# TECHNICAL BULLETIN

## MAIN WINCH INTERFACE

MAIN WINCH INTERFACE REFERENCES DRAWING : G1301-XXX\_Interface (XXX= Drass Job)

MAIN WINCH BRAKE CYLINDER REFERENCE DRAWING : 016615

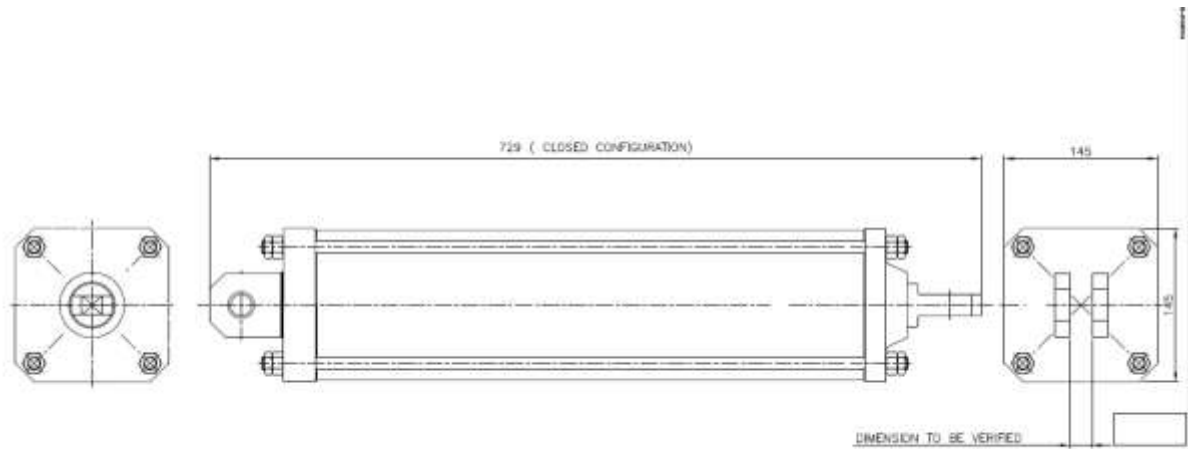
SOME REPLACEMENT CYLINDERS HAVE BEEN FOUND TO HAVE A DIFFERENCE IN DIMENSION BETWEEN THE MOUNTING LUG AND THE CYLINDER FORK.

CHECK THE GAP BETWEEN THE 2 CYLINDER LUGS AS PER DRAWING,

IT IS NECESSARY TO CHECK THE DIMENSION AS SHOWN ON ABOVE DRAWING AND ENSURE THAT ALIGNMENT BETWEEN PARTS IS CORRECT. IF REPLACEMENT CYLINDER DOES NOT FIT, CONTACT DRASS AND CYLINDERS WILL BE REPLACED.
